Renovations to:
Myrtle Grove Middle School
901 Piner Road, Wilmington, NC 28409

Addendum No. 1

Owner: New Hanover County Schools
6410 Carolina Beach Road
Wilmington, NC 28412

February 15, 2018

REPLACE sheet C5-04 with revised drawings C5-04 Addendum No. 1 dated February 15, 2018, attached hereto.

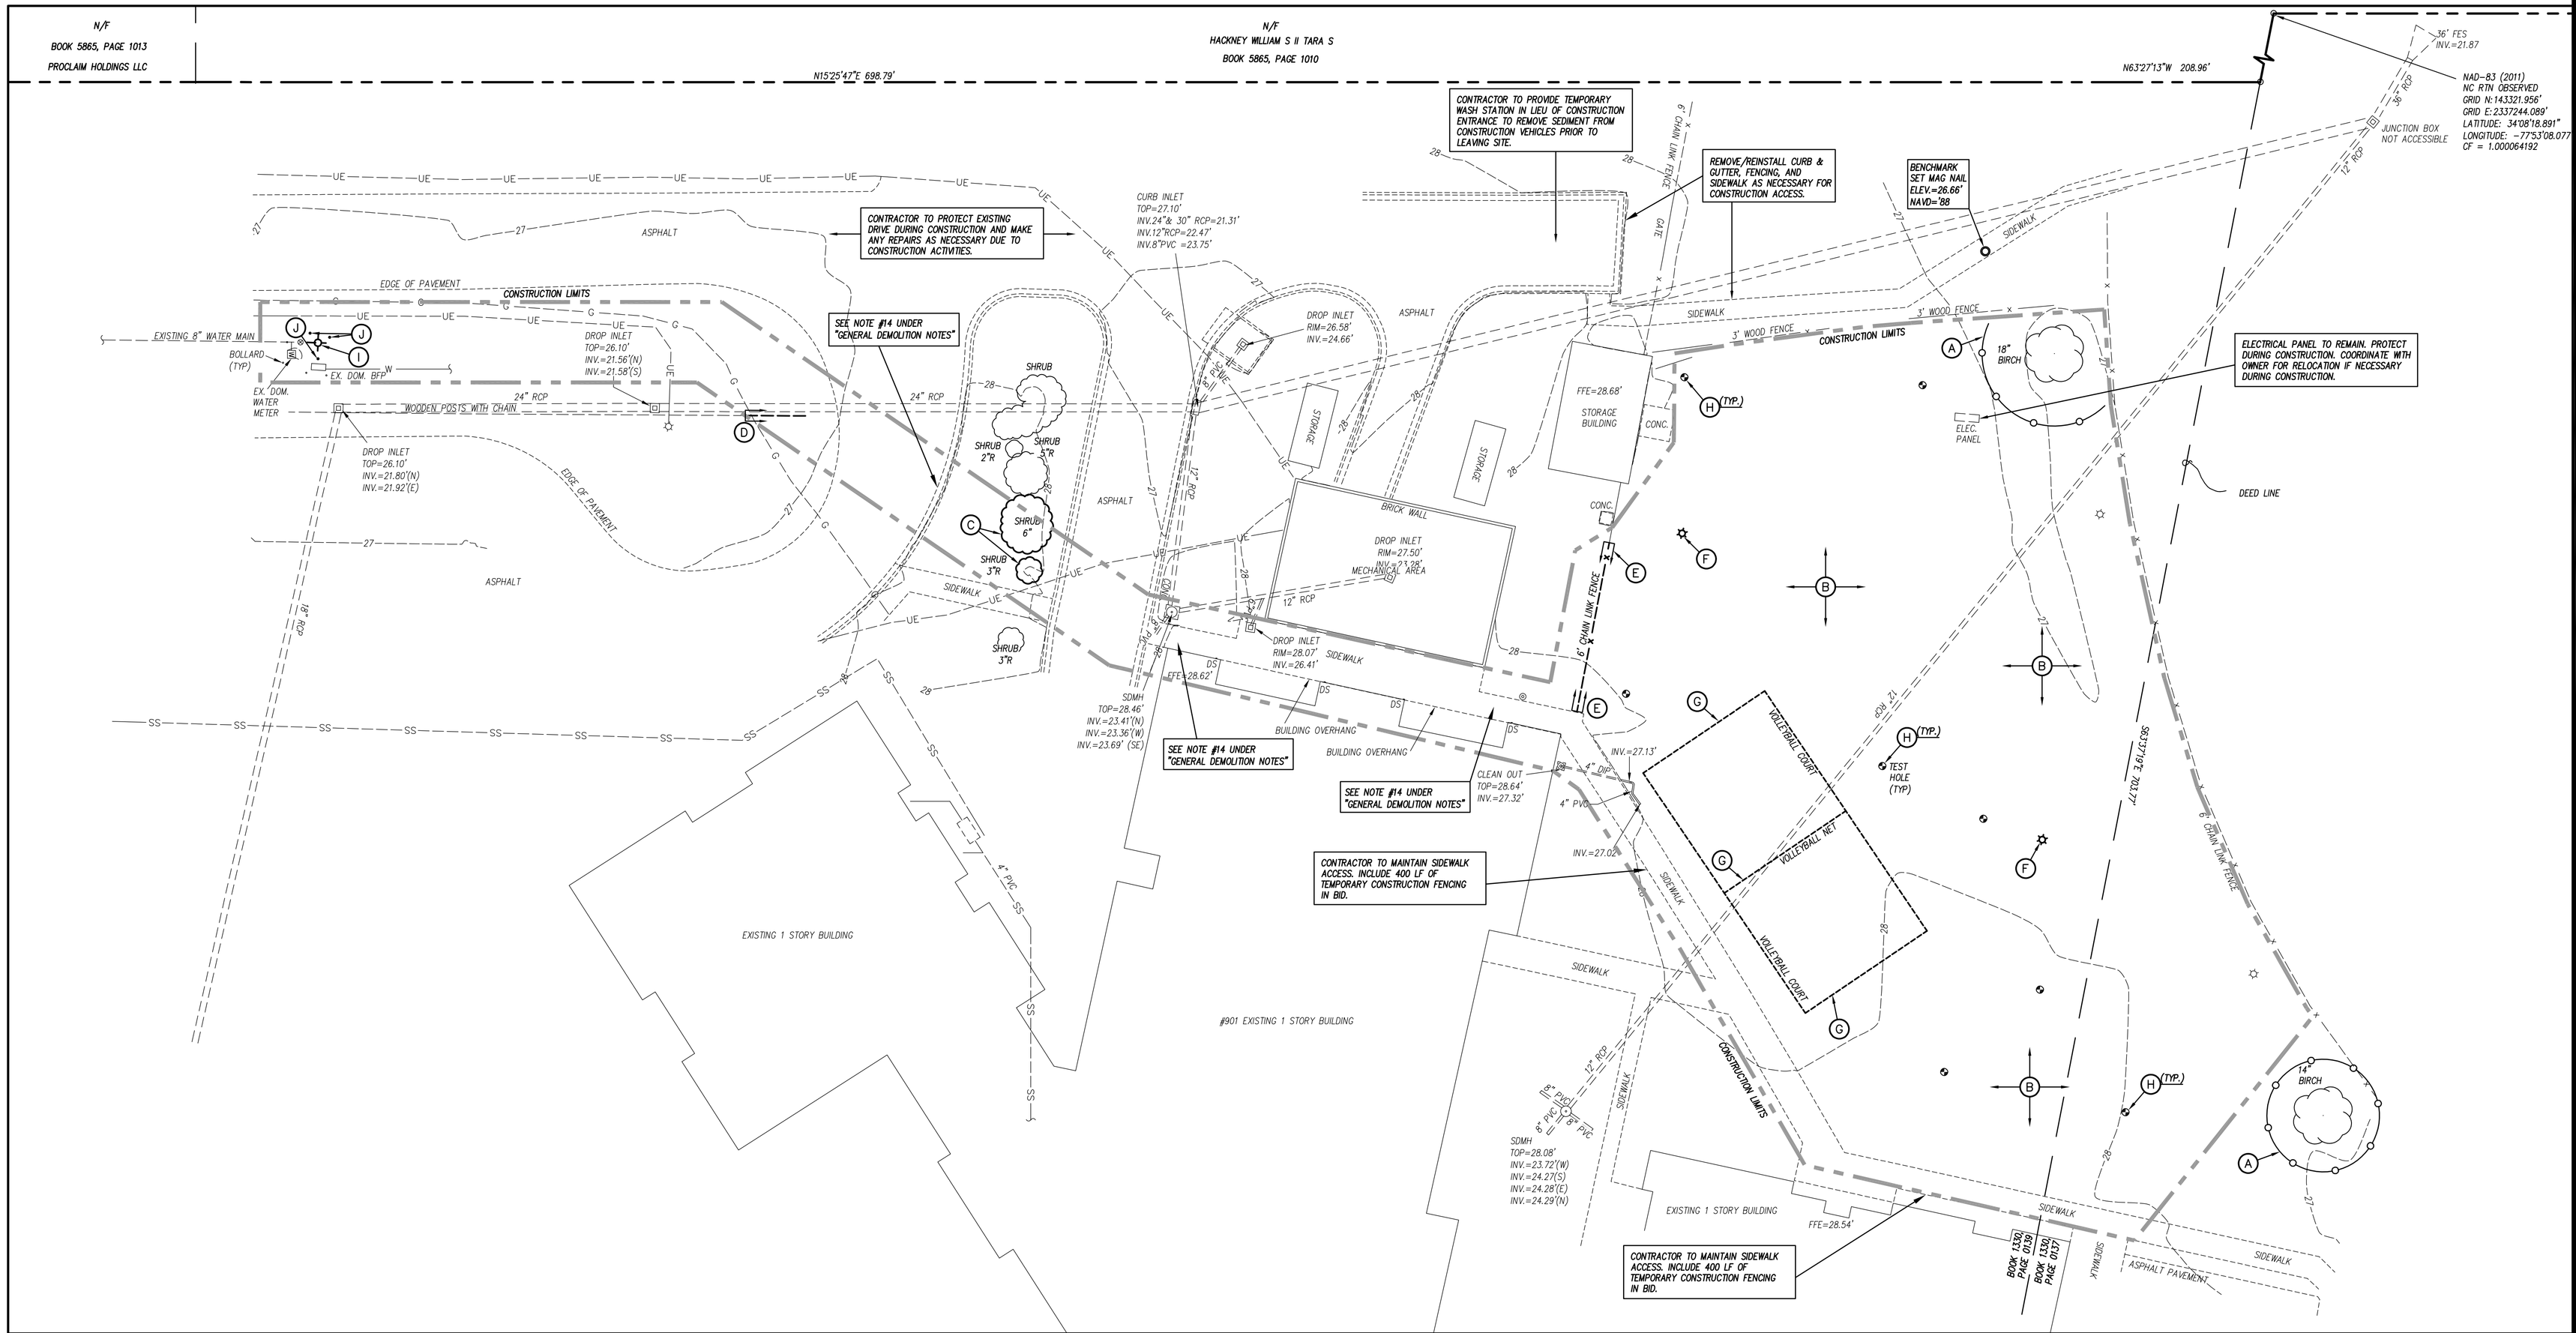
Revisions:
1. Revised Pump Station Detail.
